P-4601-1  
 15753-ISSUE-2  
 20096

**JINDAL ALUMINIUM LTD.**  
 BANGALORE-560073 (INDIA)

PARTY'S NAME	GENERAL CATEGORY ,. CHENNAI MARKET
PARTY'S DRAWING No.	AS PER SAMPLE & AS PER REQUIRMENT
ALLOY & TEMPER	HE9 WP
DESCRIPTION	MISC HOLLOW

DRAWING No.	SECTION No.
P-4601-1	-
15753-ISSUE-2	15753-ISSUE-2
20096	20096

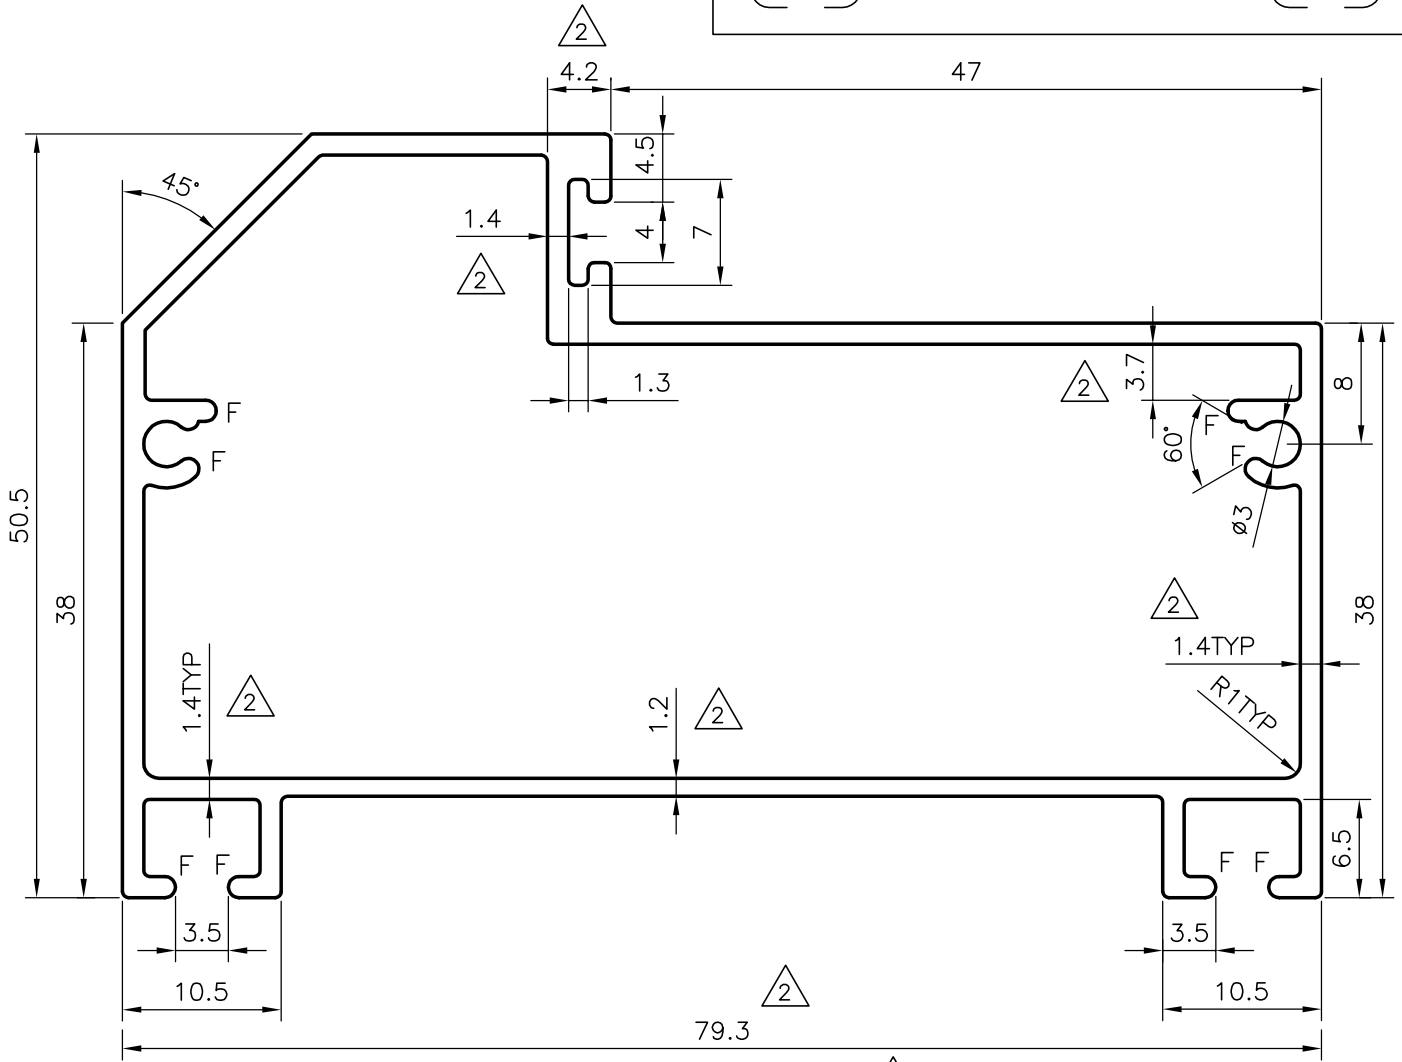
△ DIMENSIONS CHANGED FROM  
 63.60 TO 79.30  
 04.30 TO 04.20  
 03.50 TO 03.70  
 01.50 TO 01.40

& WEIGHT ALSO CHANGED FROM 1.082kg/M TO 1.108kg/M
